## Chesapeake Bay Critical Area Conservation Plan 12339 Hatton Point

**CBP-2024-004**

STAFF REPORT

SUBJECT:       Chesapeake Bay Critical Area Conservation Plan CBP-2024-004  
                  Variance to Section 5B-121(e)  
                  Variance to Section 5B-114(e)(7)  
                  12339 Hatton Point Road

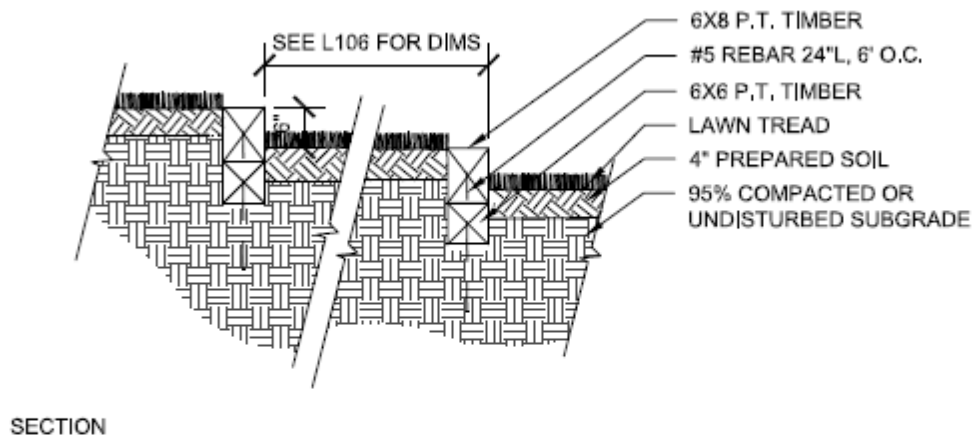
The on-site steep slopes are located along the northern property line. There is an existing pathway to the water from the house within the steep slope area. The applicant proposes to improve this existing pathway to make a safe, sturdy walkway with landscape timber steps and grass landings. Given that the walkway improvements will occur in a previously disturbed area of the steep slopes, these walkway improvements are the minimum reasonably necessary given the site conditions.

Currently, the site has no SWM controls. The house was constructed prior to SWM regulations and now needs to conform to current SWM regulations. The approved SWM concept plan proposes stormwater to be directed to one micro-bioretention facility to treat the stormwater on-site. This SWM facility needs to properly drain the stormwater without causing on-site erosion. The stormwater will be directed down gradient to outfall in a swale that is within the on-site steep slopes. Grading, SWM outfall structure, and riprap are proposed at this outfall location. The applicant only proposes those portions of SWM infrastructure which must be on steep slopes, to be located on steep slopes. Accordingly, the variance is the minimum necessary in this respect.

SWM structures and walkway impacts within this area require a variance to impact steep slopes; thus, approval of this variance is the minimum necessary.
